I2S FIFO Firmware V3.80 Upgrading

By Ian Jin 2012-07-01

New features of firmware V3.80

Jumper and terminal locations

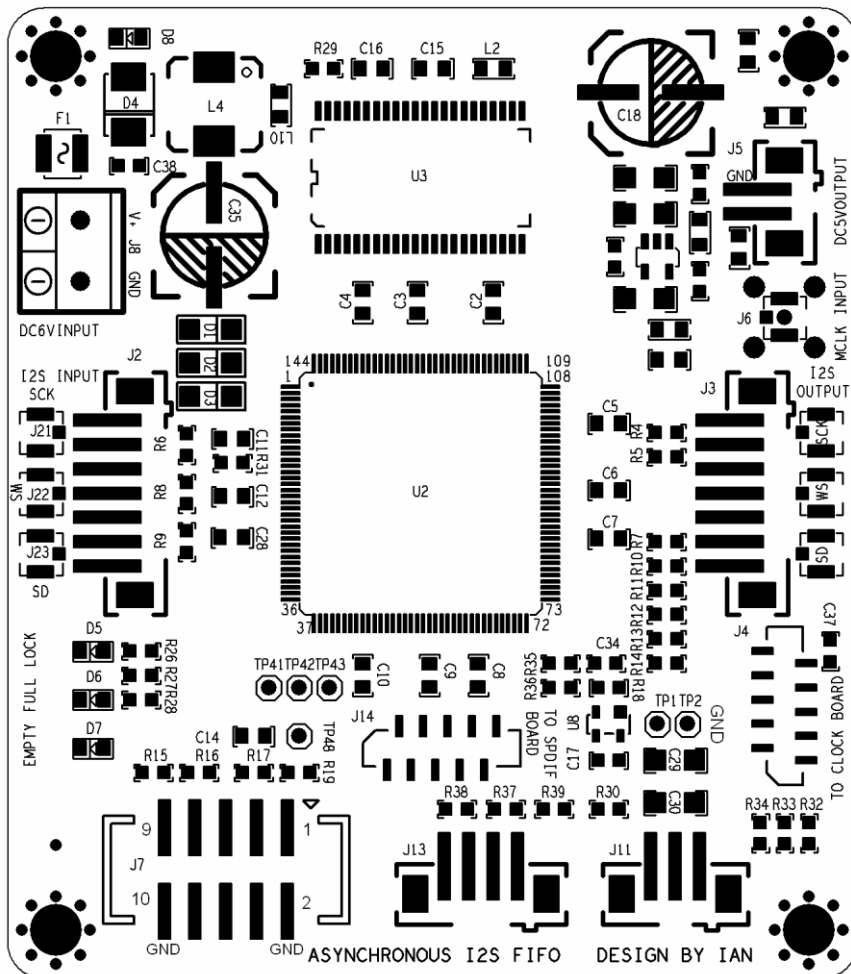
Please see the picture below for jumper TP41, TP42, TP43 and TP48 locations.

Please note that the GND terminals are located at pin J7.2, J7.10 and TP2

Jumper settings	Single XO Clock Board XO frequency required	
TP48 left open	$MCLK = 256 * Fs$	Factory default
TP48 short to GND	$MCLK = 512 * Fs$

Jumper settings	Output format	
TP43 left open	I2S (word width 32 bit)	Factory default
TP43 short to GND	Left justified (word width 32 bit)

TP41	TP42	Input format	
Left open	Left open	I2S (16bit-32bit)	Factory default
Short to GND	Left open	Left justified (16bit-32bit)	
Left open	Short to GND	right justified 6 bit	
Short to GND	Short to GND	right justified 24 bit
